# **ADDENDUM NUMBER 2**

**CITY OF LEMOORE**

**FOX ST & 19<sup>TH</sup> AVE ROADWAY REPAIRS**

**September 17, 2025**

ENGINEERING PLANS FOR  
CITY OF LEMOORE  
FOX STREET & 19TH AVENUE ROADWAY REPAIRS  
SHEET TITLE:  
LEMOORE LITTLE LEAGUE (ADDITIVE 3)

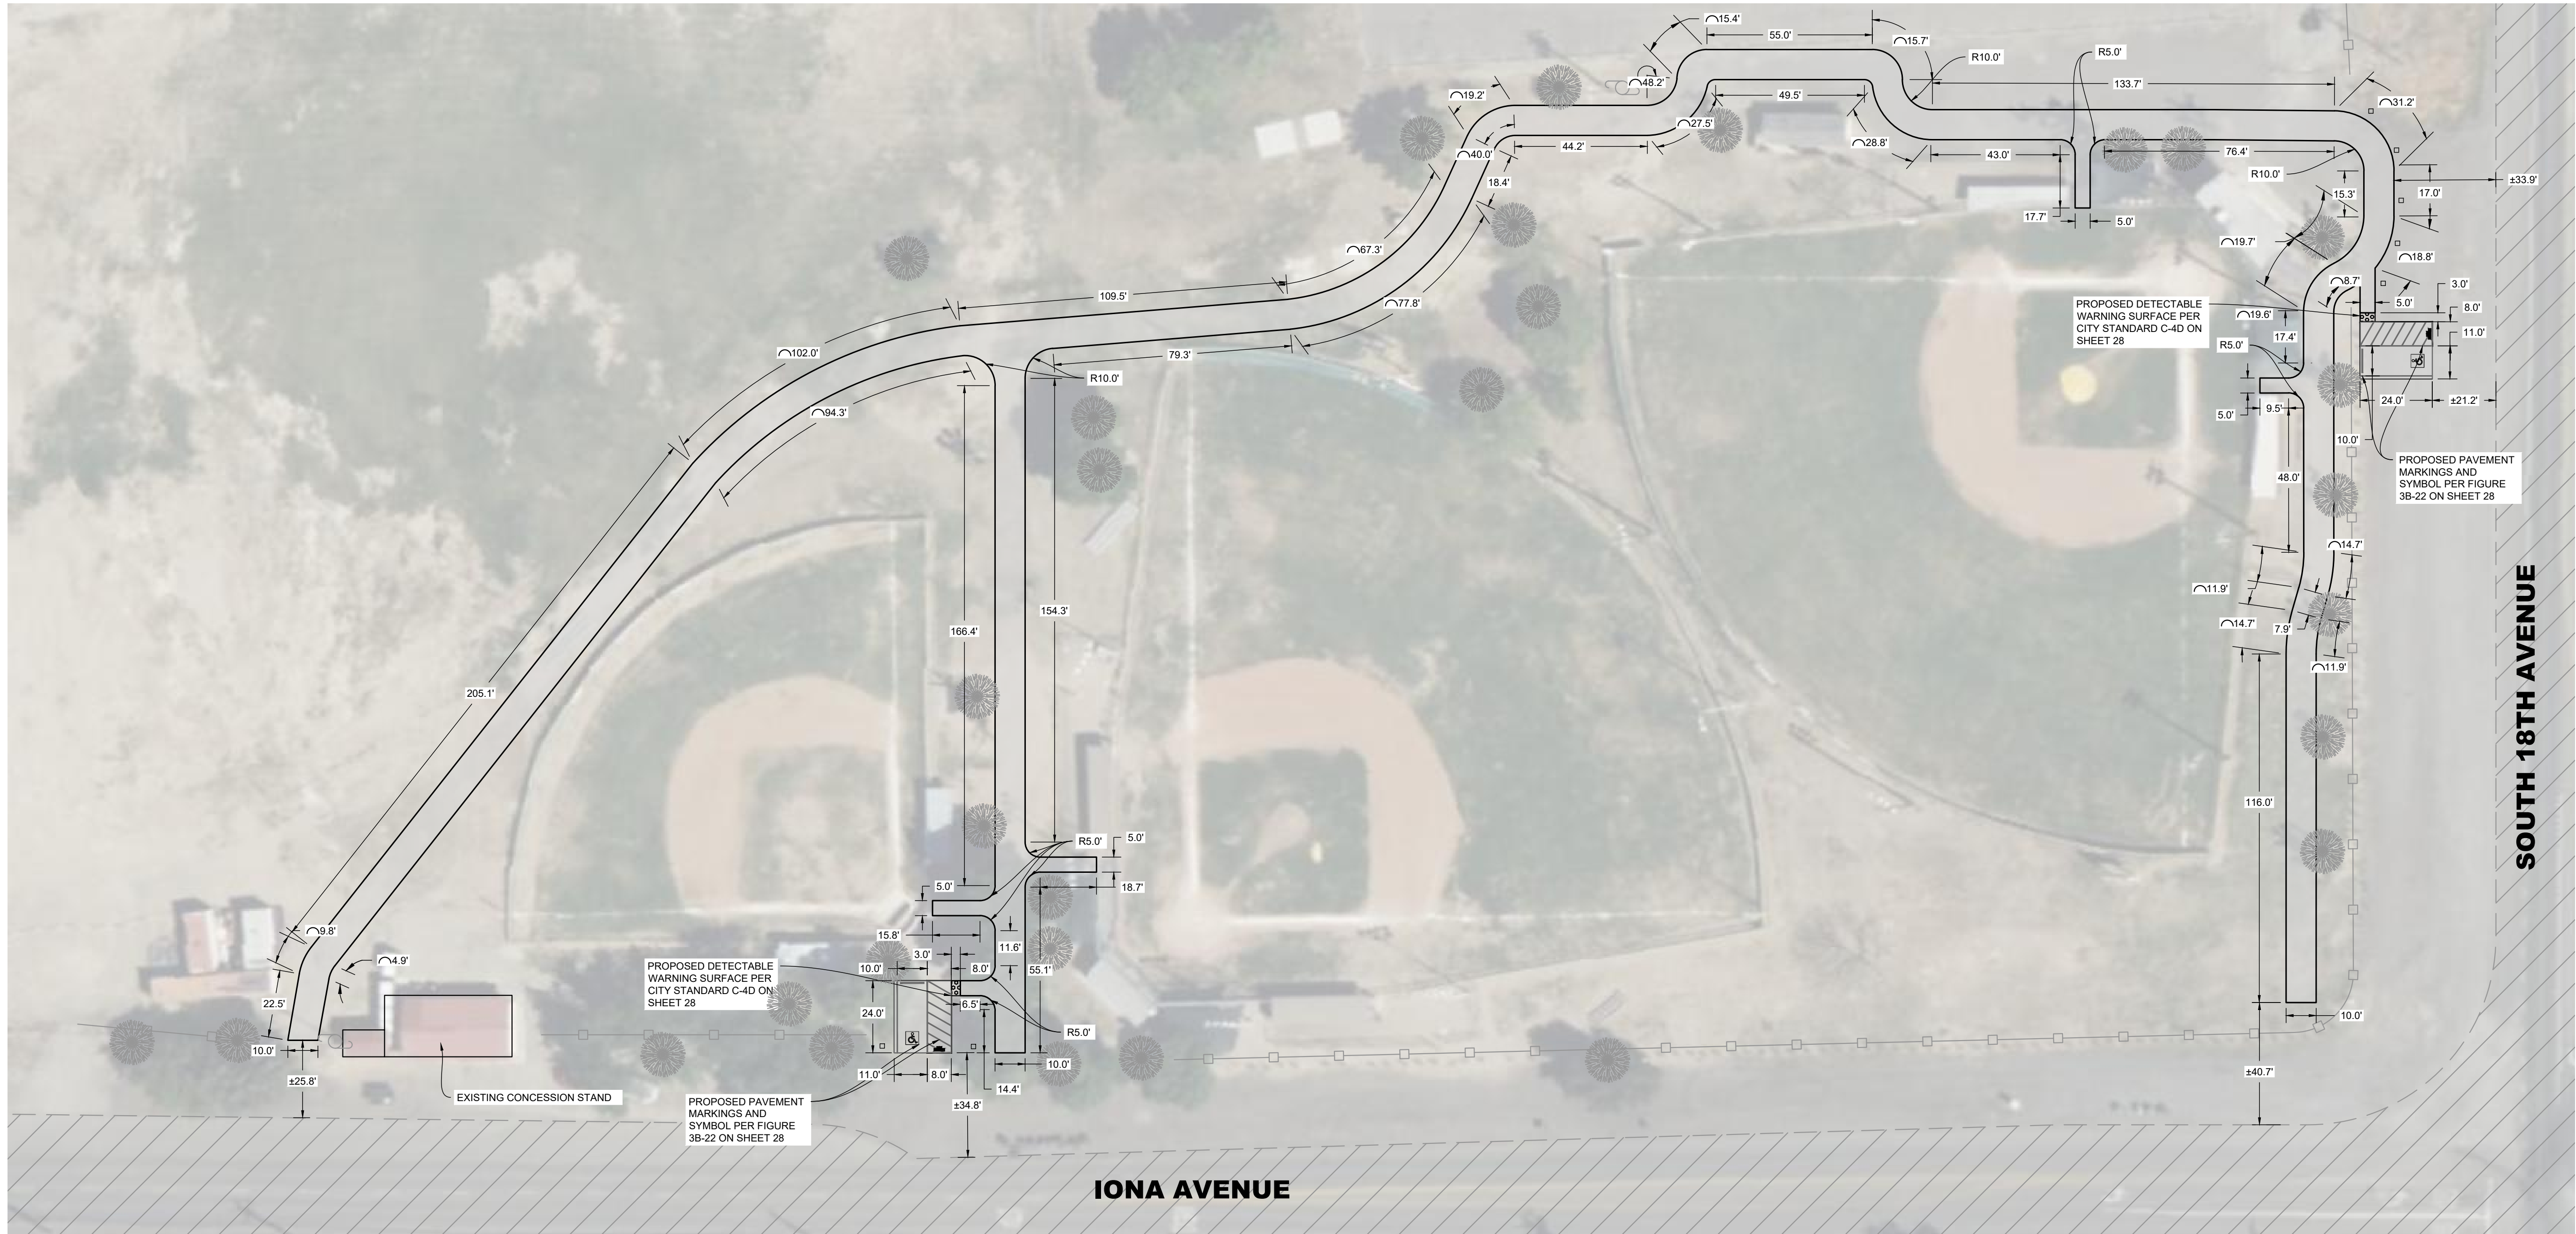
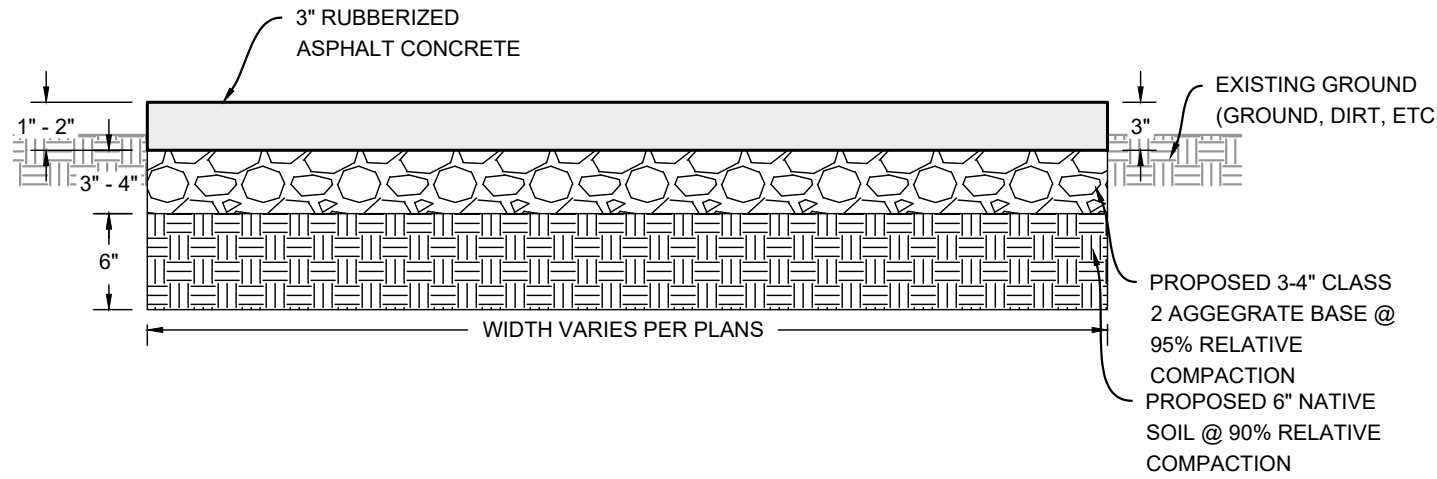
- Sheet 27 – Lemoore Little League (Additive 3)
- Sheet 28 – Heritage Park (Additive 3)
- Sheet 29 – Traffic Signal – Demolition (Additive 4)
- Sheet 30 – Traffic Signal – Improvements (Additive 4)
- Sheet 31 – Traffic Signal – Details (Additive 4)
